Planning Board Meeting AGENDA

Re: Site Plan Application Review Map 7, Lot 39 and 39-1 Warner, New Hampshire

Jennesstown Manor Site Plan Application Tax Map 7, Lots 39 & 39-1 – Warner

RESIDENTIAL SITE PLAN JENNESSTOWN MANOR MAP 7; LOTS 39 & 39-1 ROUTE 103 WARNER, NEW HAMPSHIRE

DRIVEWAY PROFILE PLAN

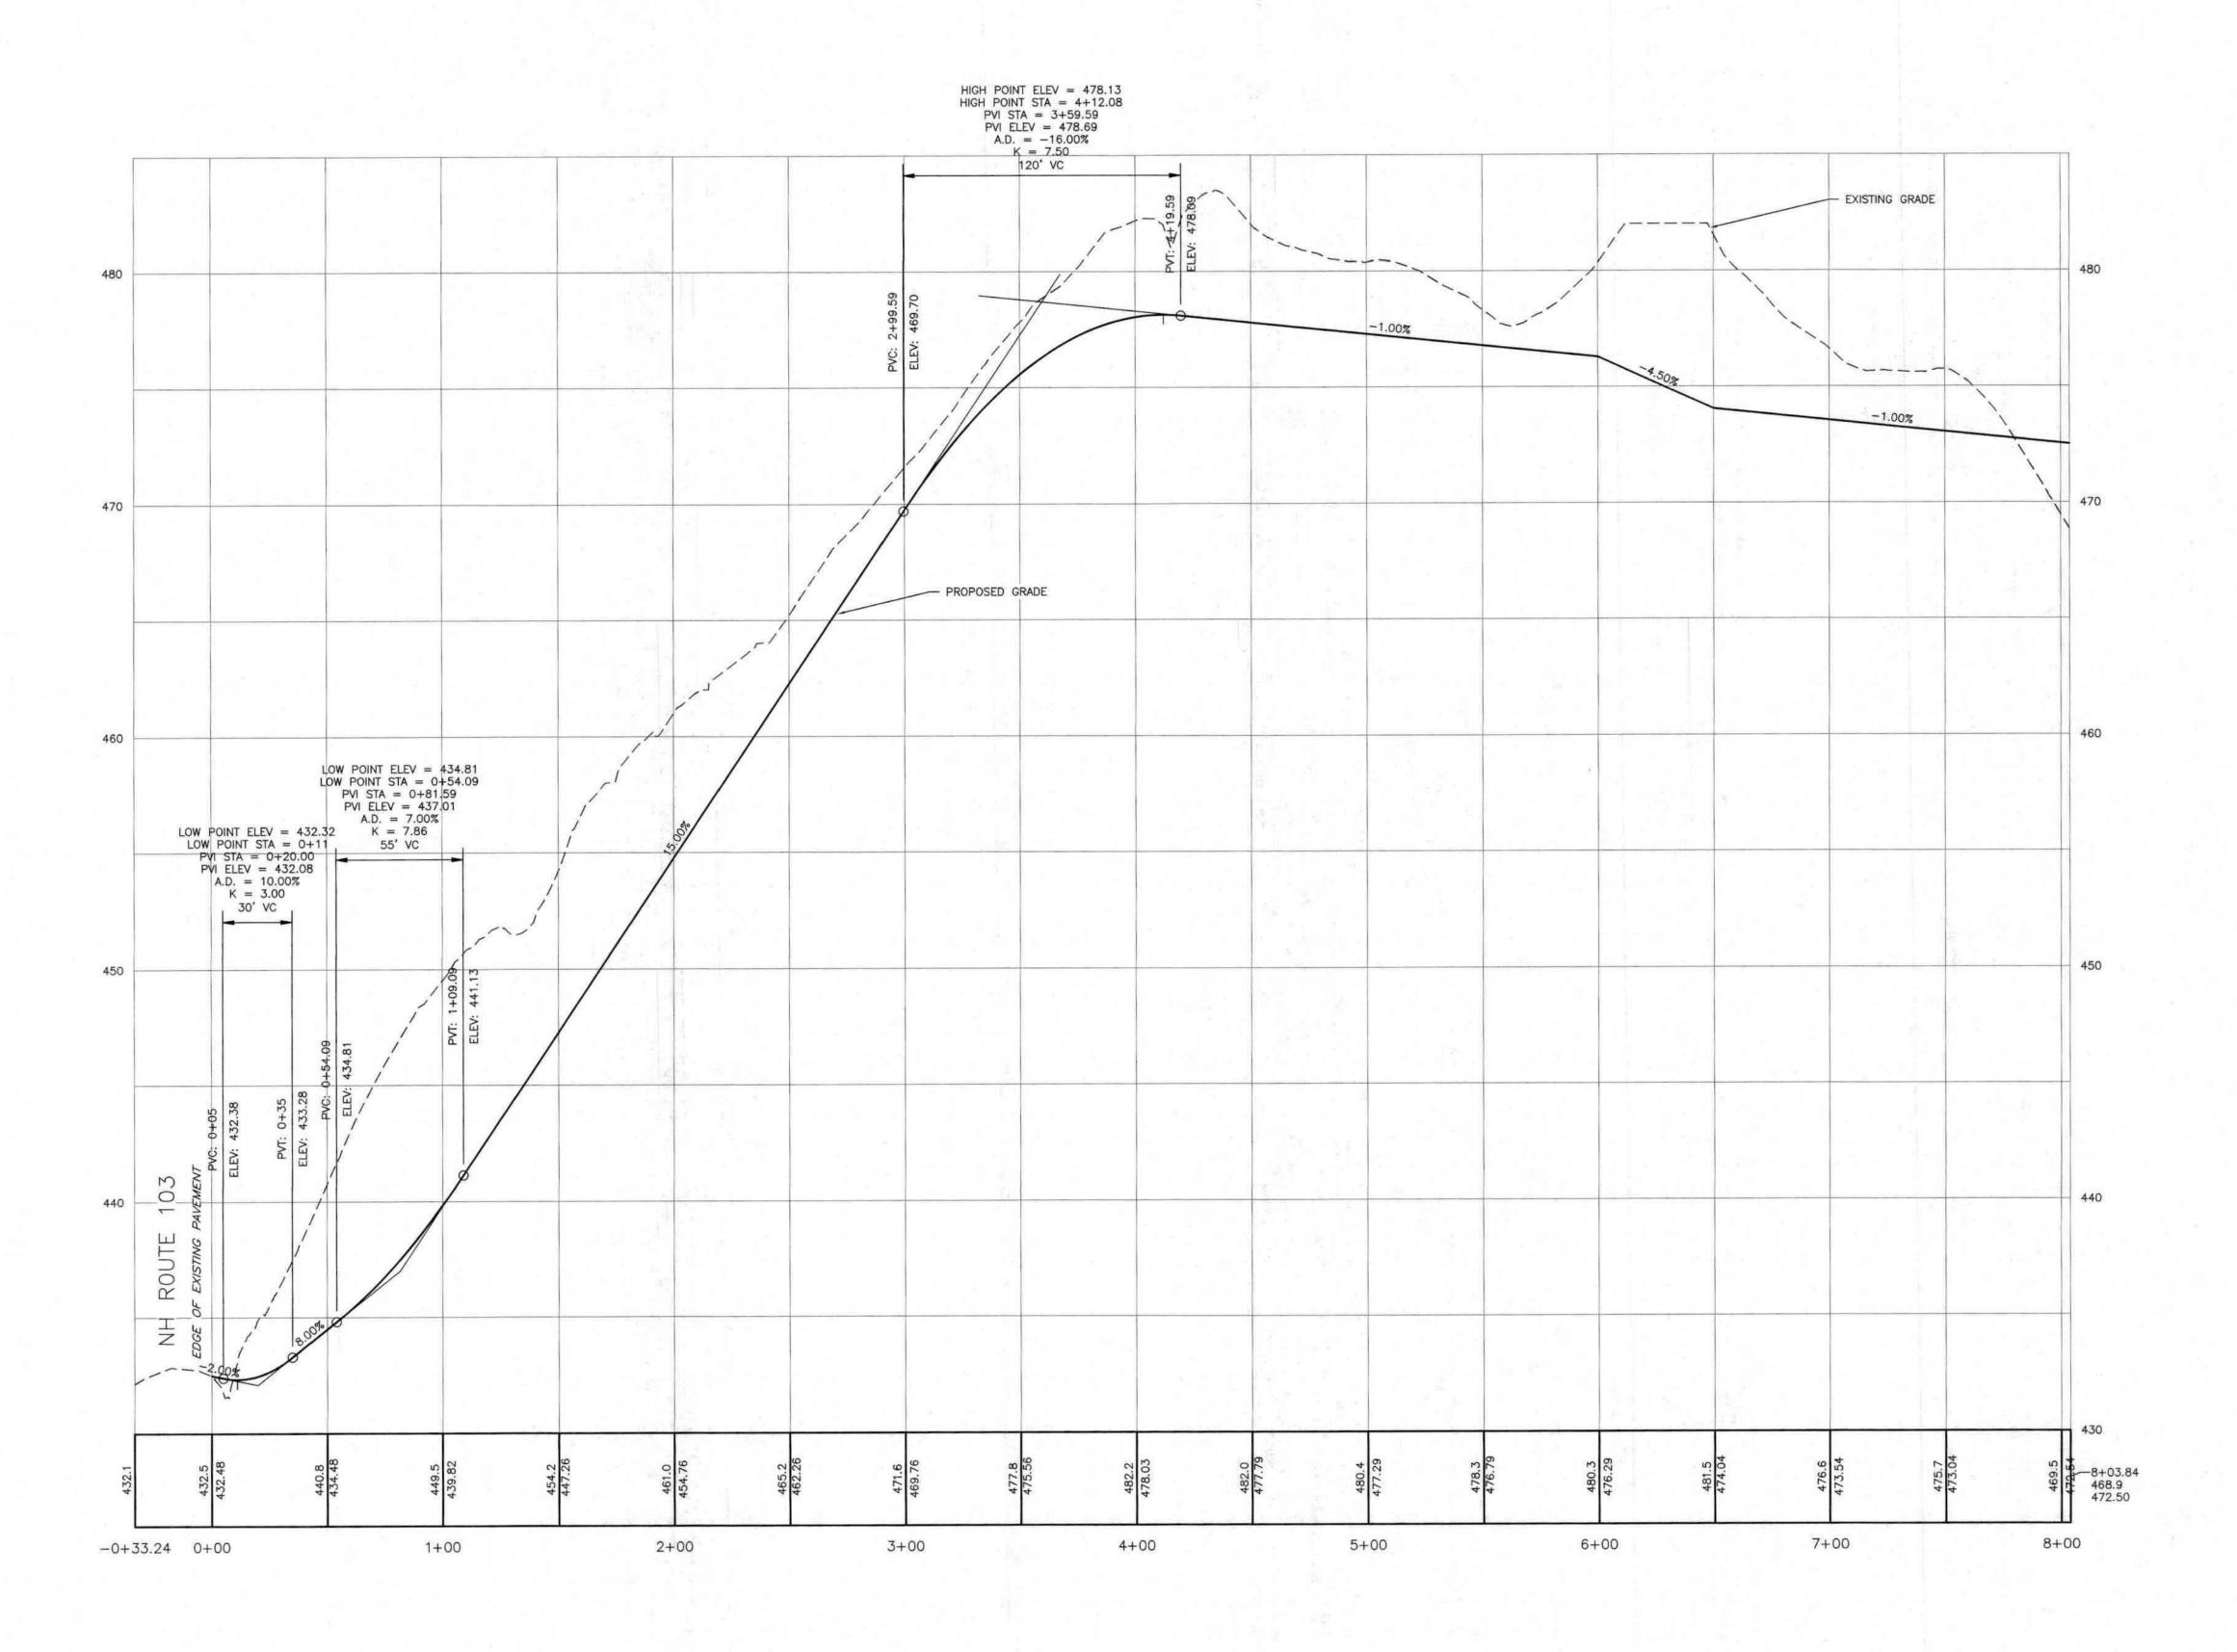
6. The site plans indicated an approximate access road starting elevation of 433 feet and a high point elevation of approximately 478 feet for the site access road, which is approximately 420 feet in length. The average grade is approximately 10.7%, while the majority of the access road is at a grade of 14.26%. Aries recommends that the proposed site access road be lengthened to meet the Section VII Design Standards grade of 10% for a local street for all portions of the access

As can be seen on Sheet 11, the centerline profile of the driveway transitions from a -2% grade, to a +8% grade to a +15% grade. Between each change in slope a transition vertical curve has been added. This permits the appropriate platform adjacent to the roadway. To reduce the grade from 15% to the suggested 10.7% grade the point of vertical curve at the top of the "hill" would result in an additional 12 foot cut into the slope. This would also cause the structures to be about 10 lower. We have chosen to hold the 15% grade outlined in the driveway regulations to minimize the cuts and constructability of the project. No modification has been made.

Q:_project\2403071\dwg\Working Drawings\Fire Truck Template.dwg, 11/3/2025 2:18:53 PM

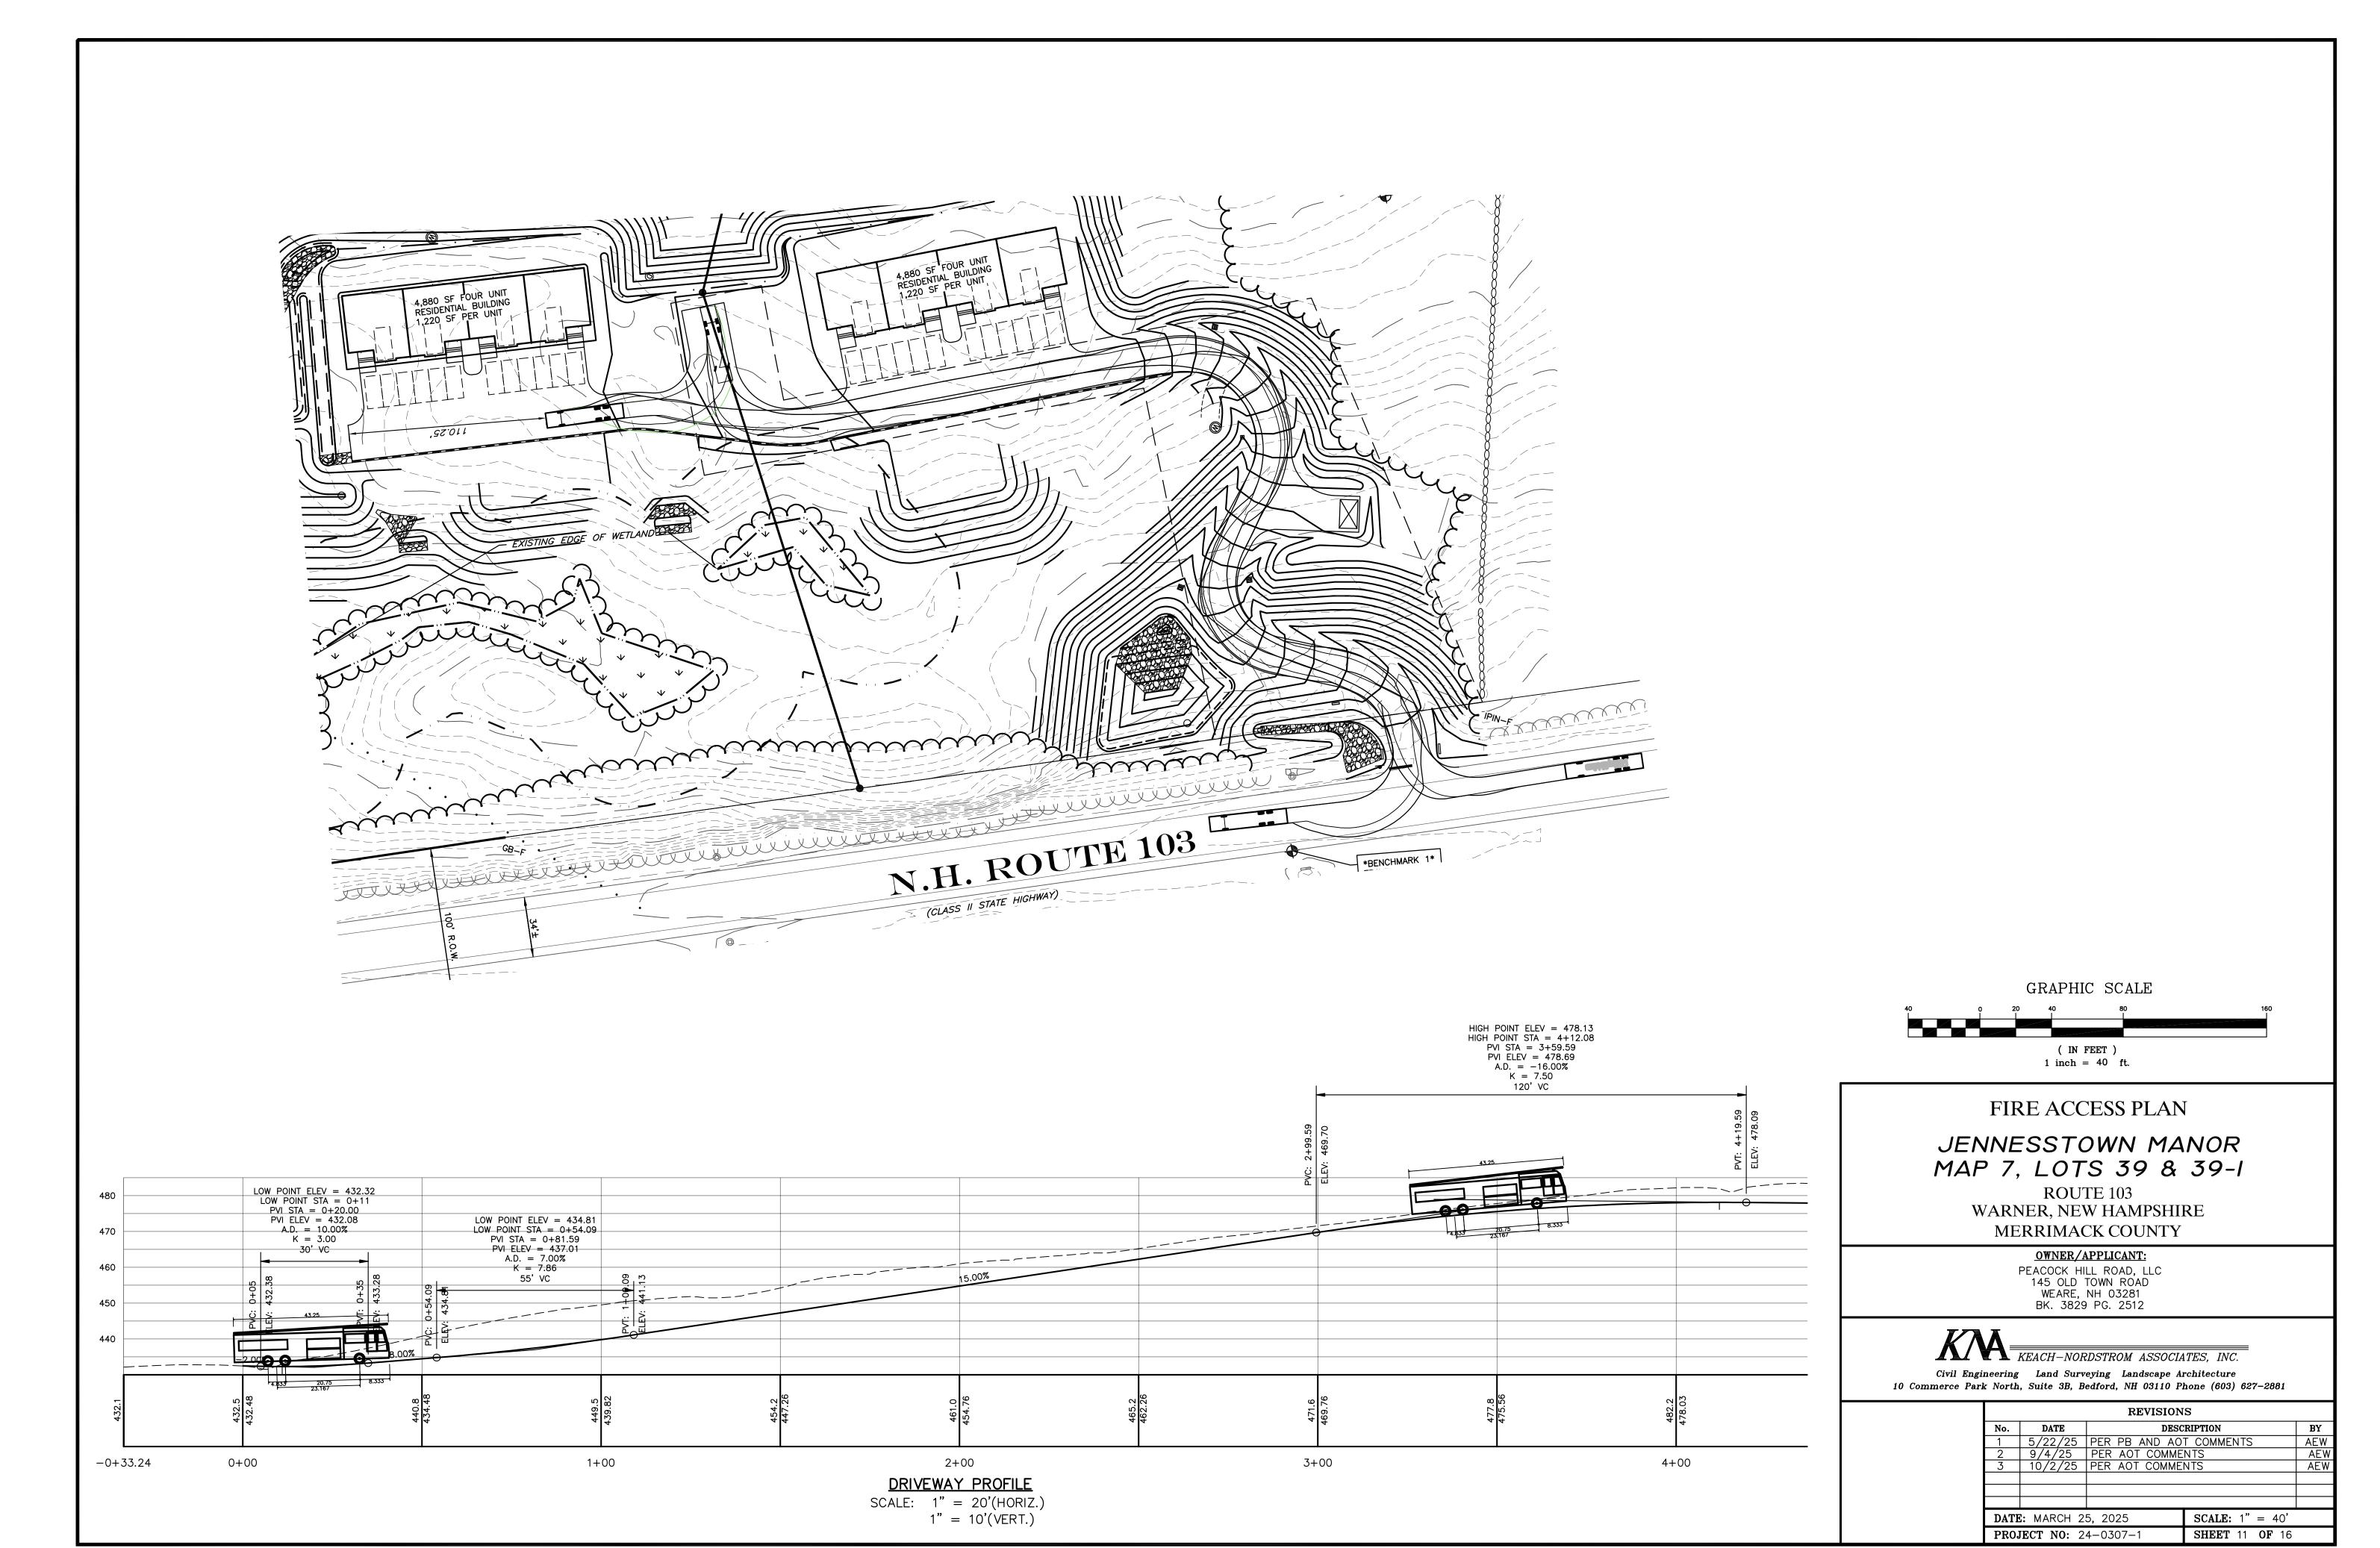
- 1. The State Fire Code (NFPA 1, 2021 edition, Chapter 18) requires fire department access. Please clarify the following:
 - a. Show turning template for FD access on site plan. We use the 40' bus template.

A Fire Access Plan has been attached to show the turning template.

The vertical approach angle is demonstrated in the profile view on the Fire Access Plan.
